Westside Purple Line Extension Project, Section 3

Addendum to the Final Environmental Impact Report

June 2018

Figure 2-7: Bus and Passenger Drop-off Areas – Proposed

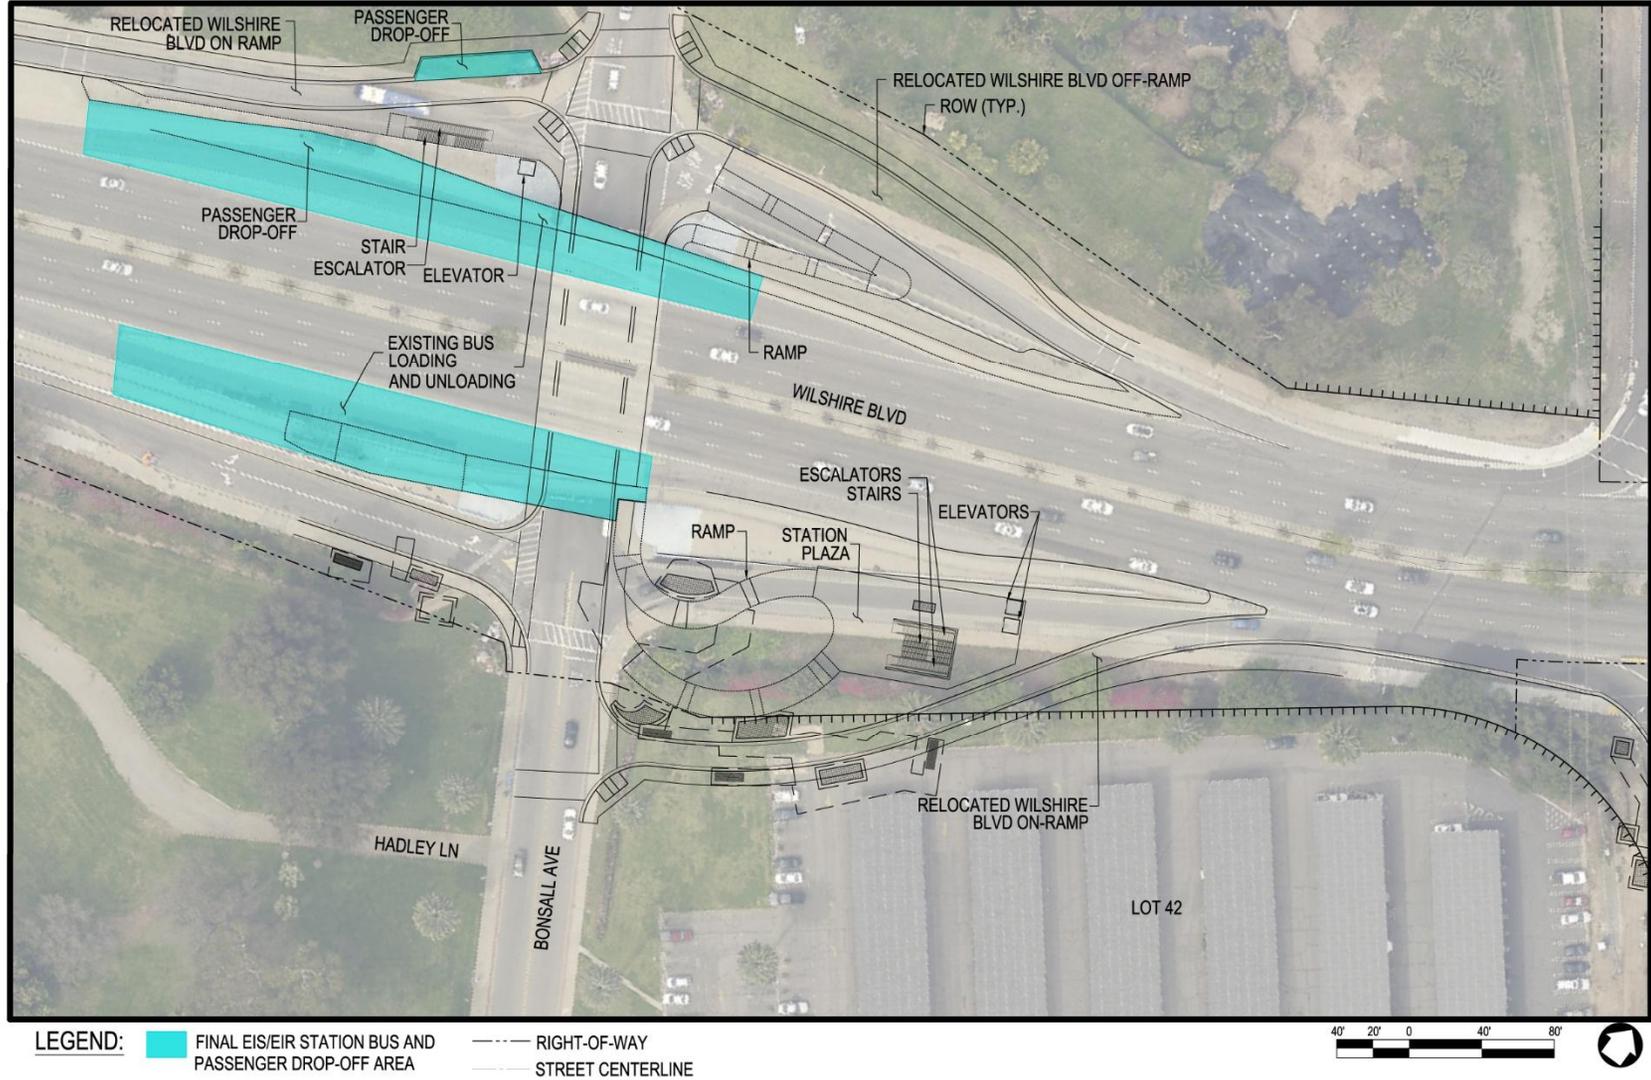
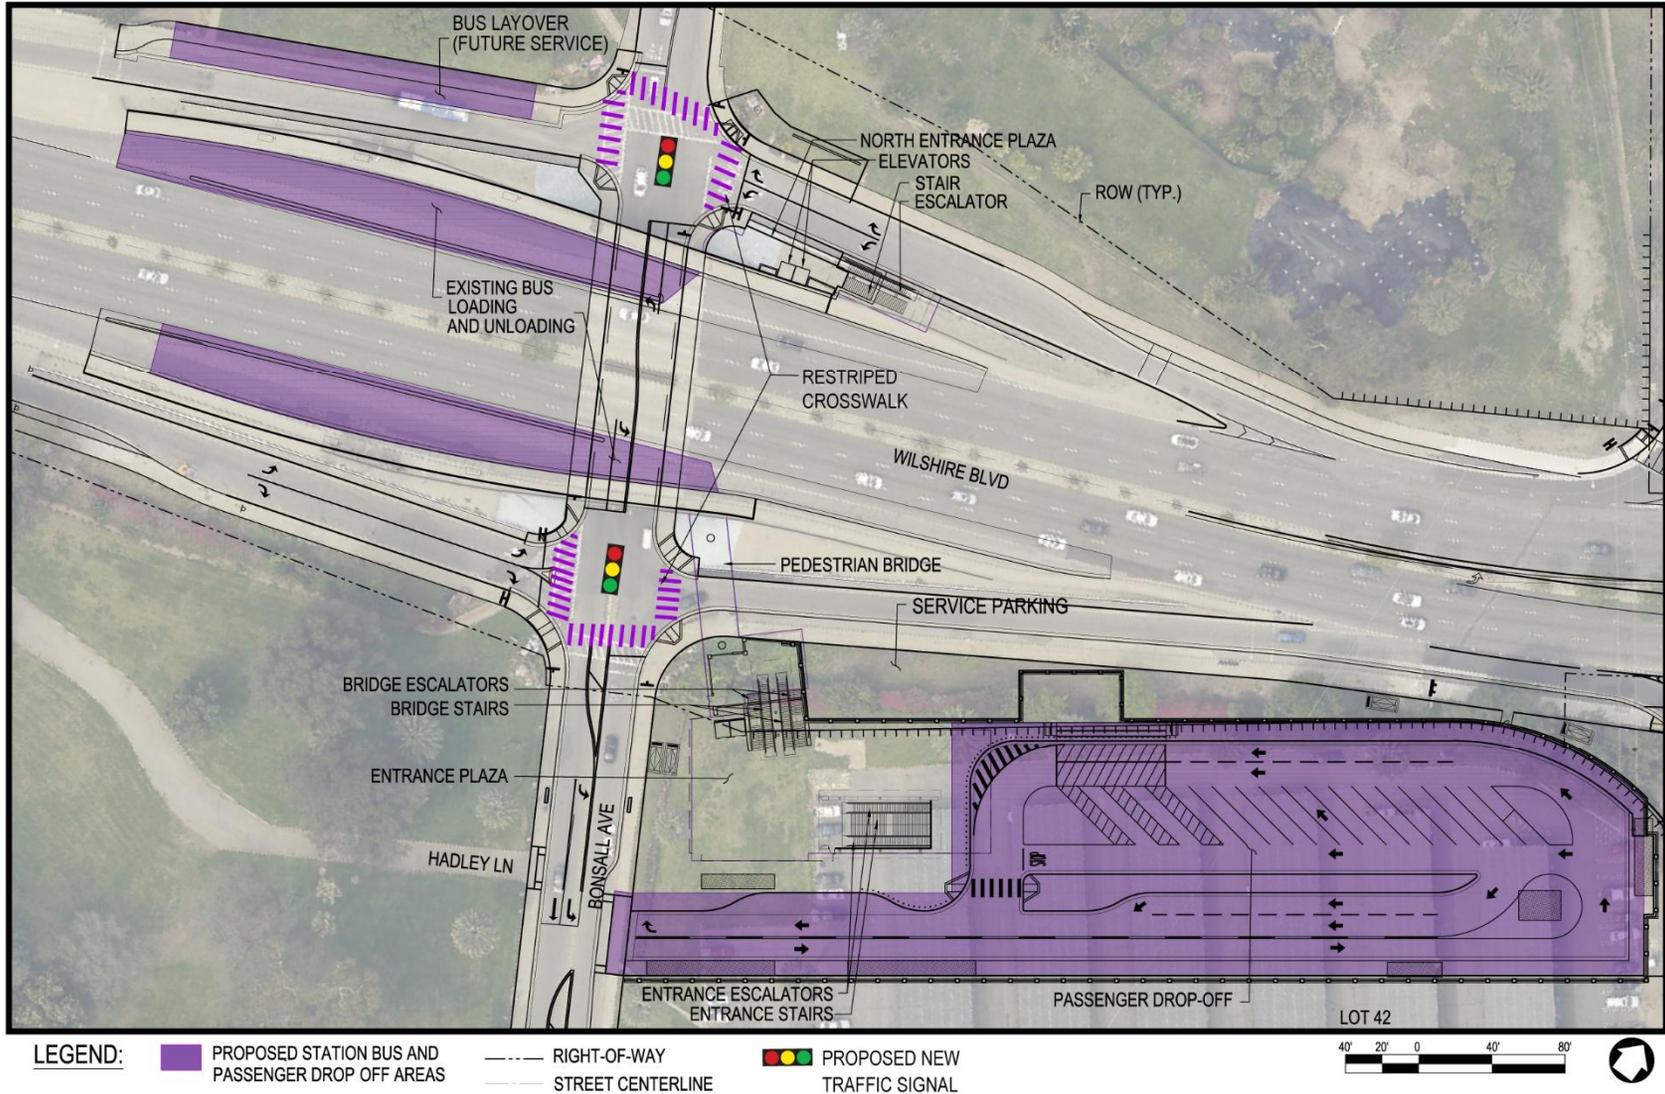
As a result of further design, it was determined that the westbound access ramp from Bonsall Avenue to Wilshire Boulevard was too short to accommodate a passenger drop-off area. Additionally, the slope of the ramp is not ADA compliant to accommodate drop offs without requiring substantial modifications. There was also concern that informal passenger drop off would occur from various locations on the VA WLA Campus. Therefore, through coordination with representatives of the VA WLA Campus, a formal passenger drop-off area is now proposed within the northern portion of the existing VA Hospital parking lot (referred to as Lot 42) just east of the proposed station plaza and entrance (Figure 2-7). The passenger drop-off area would have approximately 40 spaces for short-term parking (15 to 30 minutes) and include lighting and traffic islands. The provision of the dedicated passenger drop-off/pick-up area would benefit the VA WLA Campus and the veteran community as it is designed to prevent Metro passengers that are not associated with the VA from being dropped off or picked up within the VA WLA Campus. Signage (including “no stopping” signs) would be located to direct Metro passengers to the drop-off area and to ensure vehicles do not stop at other points on the campus to drop off passengers. Access to the drop-off area would be via Bonsall Avenue; the new intersection would be striped with a dedicated left-turn lane. Based on analyses completed in support of design, consistent with the *California Manual of Uniform Traffic Control Devices*, a traffic signal would be required at the following two locations on Bonsall Avenue: (1) at the intersection with the Wilshire Boulevard westbound on- and off-ramps and (2) at the intersection with the Wilshire Boulevard eastbound on- and off-ramps. These locations are currently all-way stop sign controlled. The passenger drop-off area would be designed to accommodate bus service operated by the VA Medical Center; however, public transit provided by other operators (e.g., Metro) would not utilize the drop-off area.

A bus layover area located on Los Angeles County property has also been included along the westbound on-ramp from Bonsall Avenue to Wilshire Boulevard at the request of Metro’s Bus/Rail Interface group (Figure 2-7). This layover area would allow for the provision of additional future services to West Los Angeles and Santa Monica. To accommodate the bus layover area, the ramp would be widened, which would extend into the adjacent sloped lawn area. The widening would occur within Los Angeles County property.

Figure 2-8: Murals

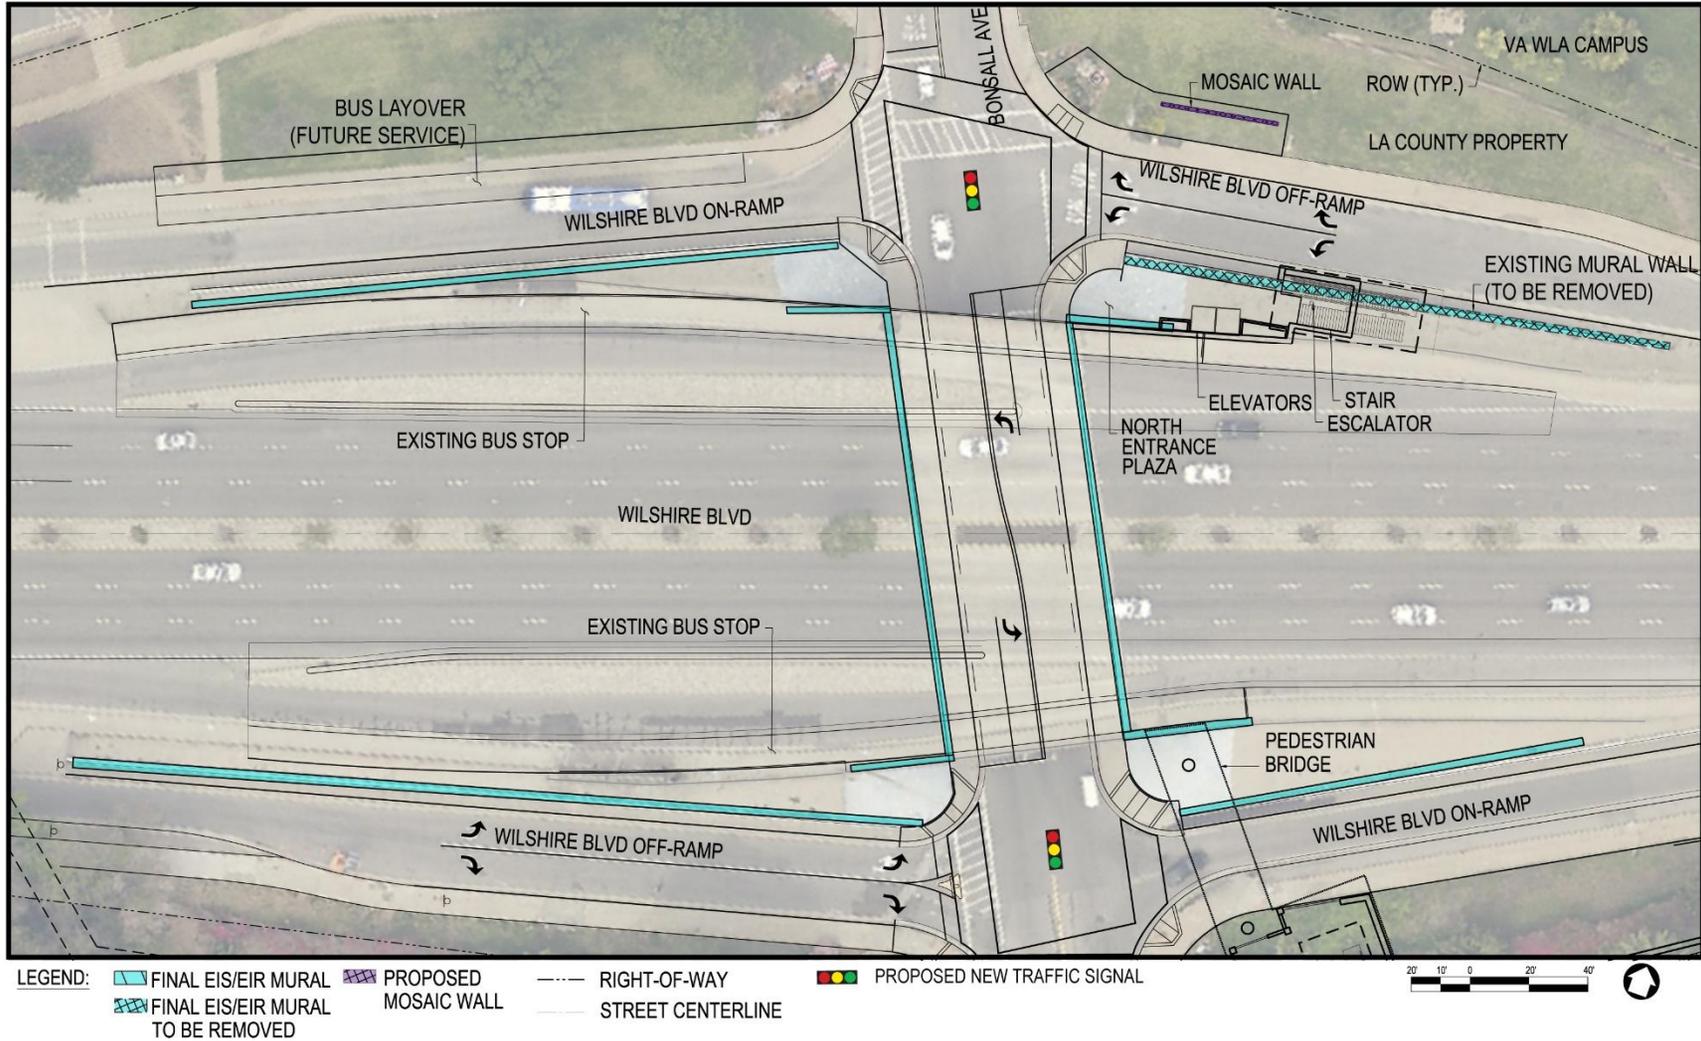
The Final EIS/EIR identified military-themed murals painted on the walls of the Bonsall Avenue underpass and access ramps to/from Wilshire Boulevard (Figure 2-8). These murals, located on Los Angeles County property, were painted in 1995 by Peter Stewart and other veteran volunteers known as “the crew” and are public art. The Final EIS/EIR assumed that the murals could be protected in place during construction of the Westwood/VA Hospital Station. However, studies conducted since completion of the Final EIS/EIR indicate that removal of the northeast mural wall along the south side of the westbound Wilshire Boulevard off-ramp to Bonsall Avenue (Figure 2-9) would be required for construction of the station circulation elements at that location. Once the stairs and escalators are constructed, there would not be sufficient space to accommodate the mural in its original location. As such, Metro proposes removal of the entire northeast mural and conveying the story of that mural in a reduced-scale version using a more durable medium of mosaic tile in another location. The mosaic wall would be located across from the current location of the northeast mural into an embankment and retaining wall on Los Angeles County property. Metro is coordinating with the VA, veterans groups (e.g., the National Veterans Foundation), and other stakeholders (e.g., the LA County Arts Commission) regarding this proposal and has received support from stakeholders. Reconfiguration of the mural into a mosaic is subject to the approval of the LA County Arts Commission and the Los Angeles County Board of Supervisors and agreement by Los Angeles County to maintain the mosaic in perpetuity.

Figure 2-10: Construction Method for Westwood/VA Hospital Station West Crossover

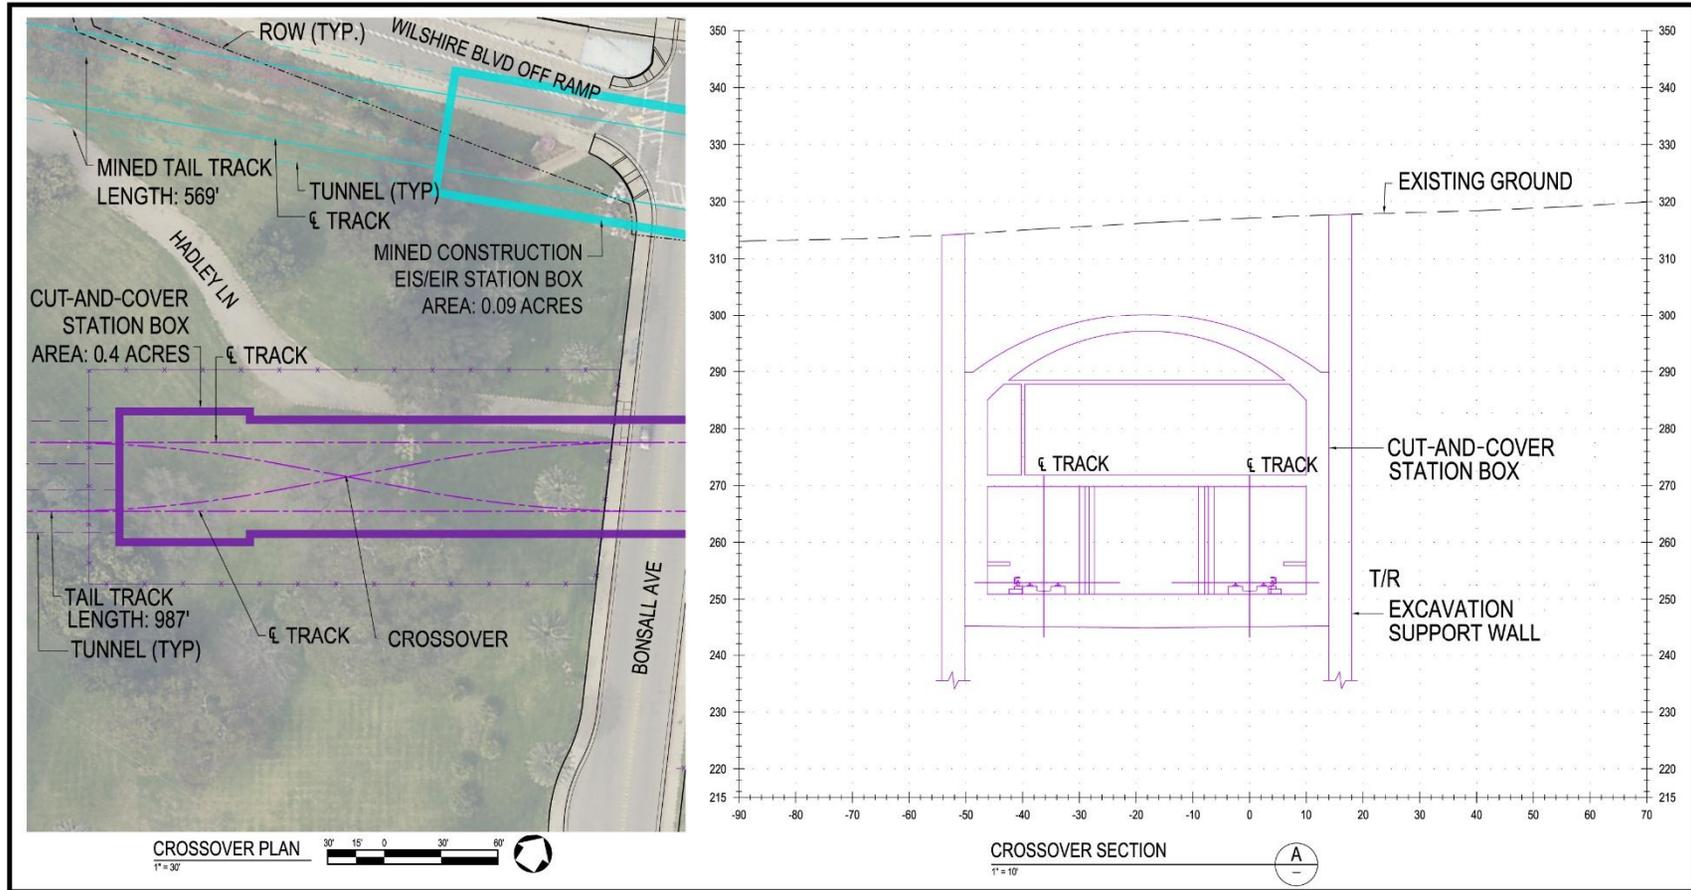
The Project as defined in the Final EIS/EIR included a crossover located west of the Westwood/VA Hospital Station platform; the crossover structure would be approximately 300 feet long. The crossover was to be constructed adopting sequential excavation mining methods at its western end (approximately 50 feet) to reduce impacts to the lawn area within the WLA VA Historic District, which is located at the surface above a portion of the crossover. The adjacent platform, and most of the crossover, which was located underneath an existing VA WLA Campus parking lot (Lot 42), was to be constructed via the cut-and-cover method. The refined alignment would move approximately 250 feet of the crossover section west of Bonsall Avenue beneath the lawn area. With the refined alignment and schedule, the tunnels would be excavated in advance of the crossover from the tail track exit shaft, and the tunnel linings would then be removed during excavation of the crossover. Geotechnical investigations completed since publication of the Final EIS/EIR for the refined alignment confirmed that sands and clays of the Younger and Older Alluvium are present (Metro 2017c). These “soft ground” soils are less favorable for the sequential excavation mining methods, which require specialized construction techniques and monitoring to ensure a safe excavation. Multiple headings (a series of small sections within the cavern face) would need to be excavated for construction safety, slowing progress of the excavation. Therefore, sequential excavation mining methods for the crossover would increase construction risks, including schedule and worker safety. As such, Metro proposes constructing the crossover via the tried and trusted cut-and-cover method, similar to the rest of the station structure. The proposed cut-and-cover area and associated construction staging area are shown in Figure 2-10.

As stated in Section 2.2, the Project is constructed as two tunnels, one tunnel for each direction of travel. At terminal stations, a crossover is required to allow trains arriving in one tunnel to cross over into the other tunnel to depart. Because a crossover allows a train to reverse direction, the crossover must connect trackwork located in one tunnel with that in the other tunnel. Typically, crossovers are constructed in a structure directly next to the station and extend for the full width of the station. The TBM tunnels are not normally sized to accommodate any portion of the crossover structure, meaning the width is insufficient to permit the movement of the train through the crossover trackwork. As stated in Section 2.7, the Section 3 tunnel diameter has increased from an outside diameter of 20 feet 10 inches to 22 feet 6 inches to permit 50 feet of the crossover trackwork to extend into the tunnels, which reduces the length of the cut-and-cover area required for the crossover within the WLA VA Historic District west of the station from 300 feet to 250 feet. The 250-foot cut-and-cover area west of Bonsall Avenue is in addition to the cut-and-cover area required for the station box east of Bonsall Avenue.
